Re: June, 2023 Trenching Program, Goldpark King No. 2 Unpatented Placer Claim,
Park County, CO (USBLM Case File No. COC-080911)

Response to Berger Ltr att. SBR e-mail Rec'd 4/8/23

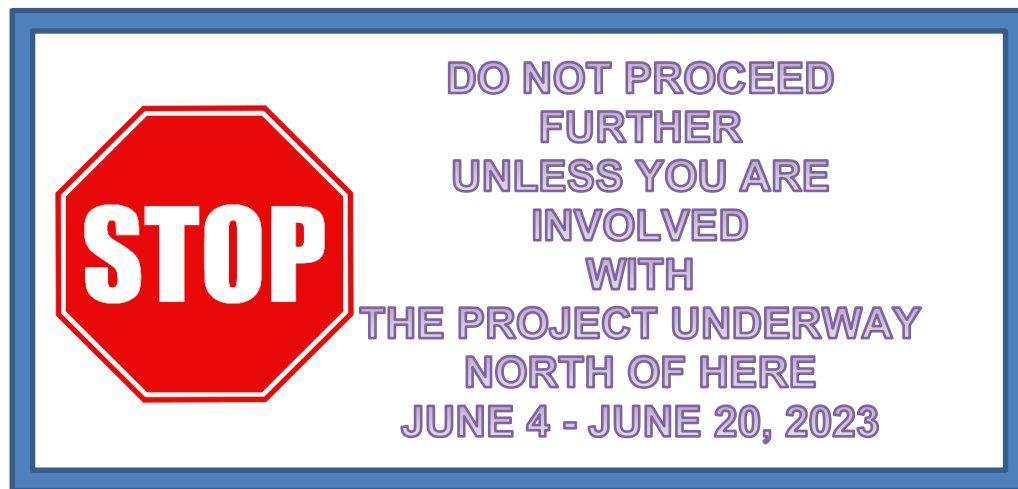
6. Describe any signage or other safety features to be used on site.

We will place a 2ft x 3ft sign by the old access road near our temporary trailer, as follows:

We will place another 2ft x 3ft sign by the new access road near its connection with the old access road, as shown below:

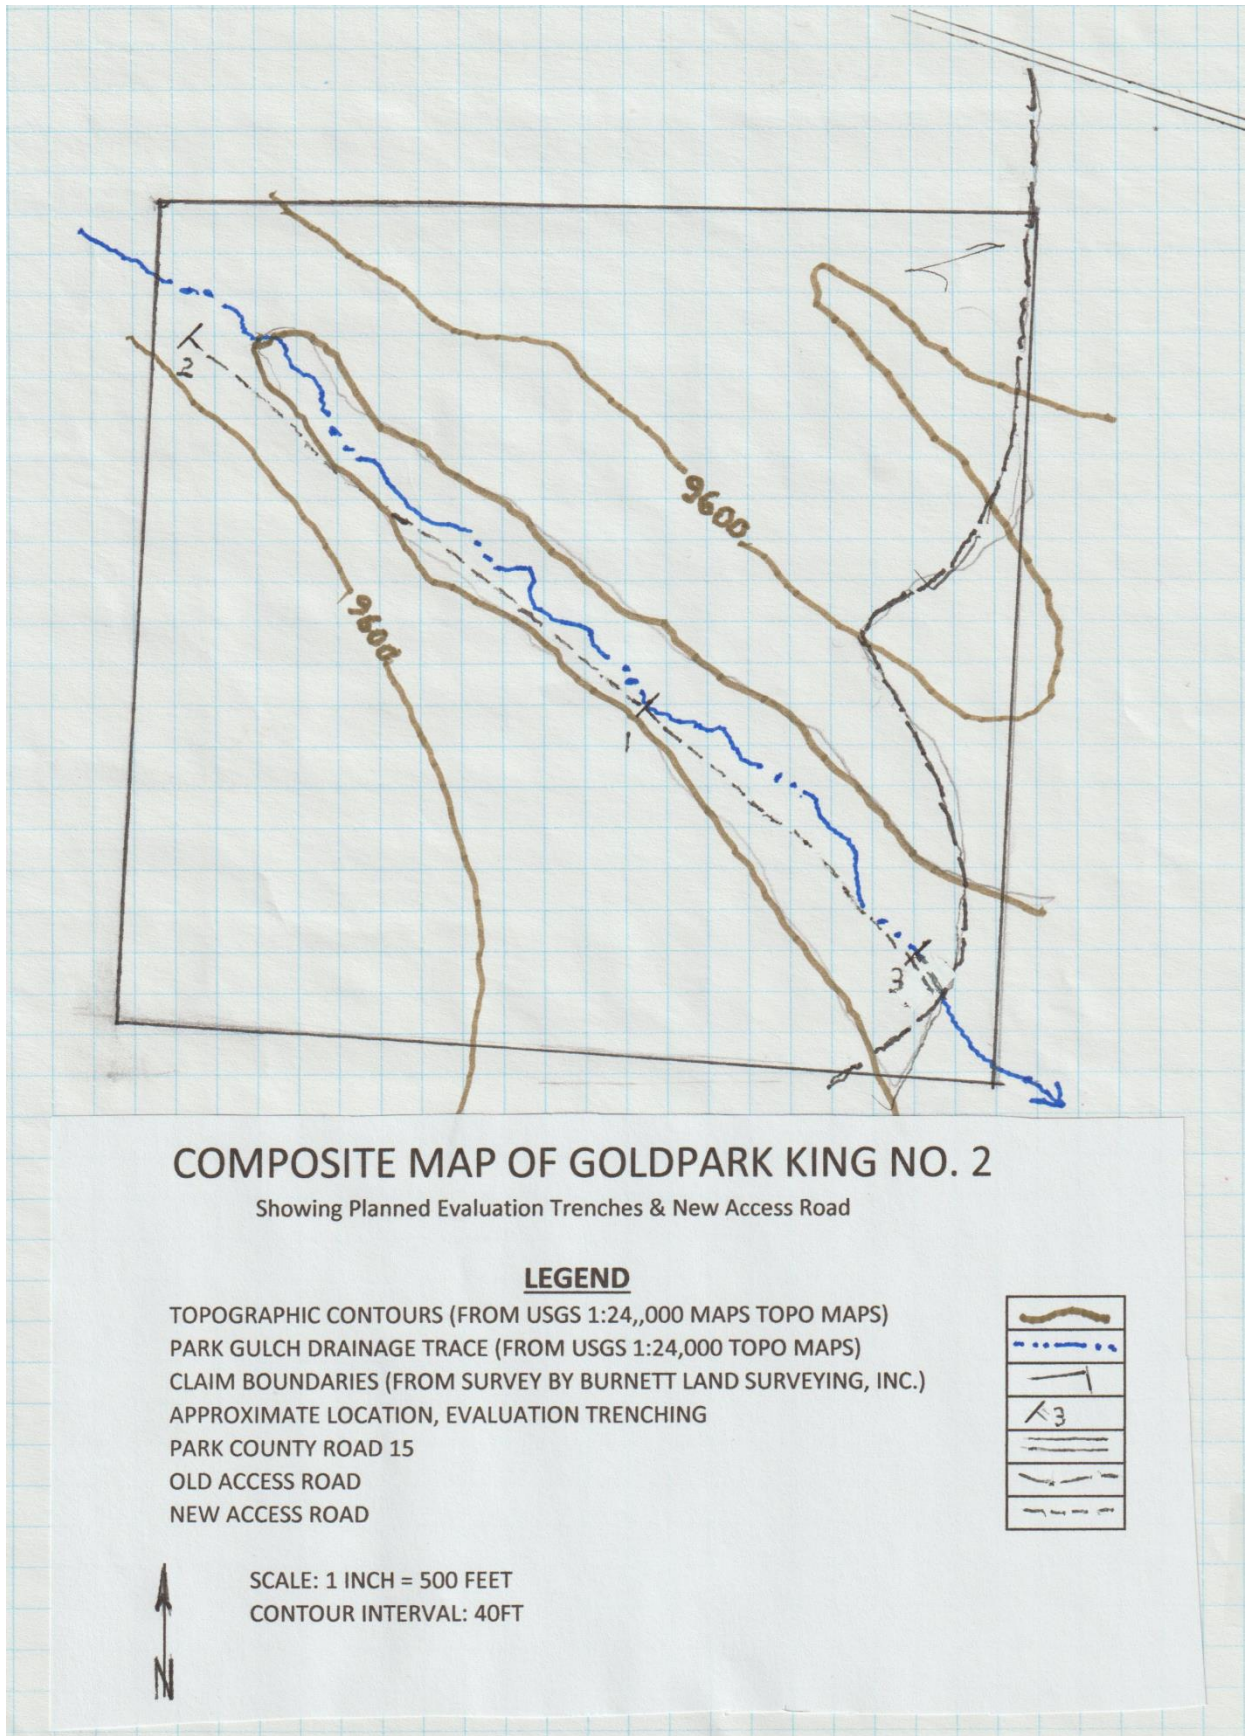
3. Provide a map or satellite image with a more detailed depiction of the exploration site, including the road and trenches' proximity to the perennial stream.

The attached composite map depicts the area of the exploration site, the road, and the trenches' proximity to what you have defined as "the perennial stream." And the two attached photos show topography and vegetation of Park Gulch in the vicinity of the trenching sites.

Your request mentions a "perennial" stream on the site. There is no such stream anywhere on Goldpark King No. 2. The drainage crossing the claim from NW to SE perhaps fits the definition of an intermittent stream, as shown on USGS topo maps of the drainage. But I doubt even that designation requires stretching the facts a bit. I've been on the claim some two or three dozen days over the past five summers, and I have yet to see any flowing water in the drainage course. I did observe a small puddle of possible rainwater or melt water once, in 2022. (See attached photo.)
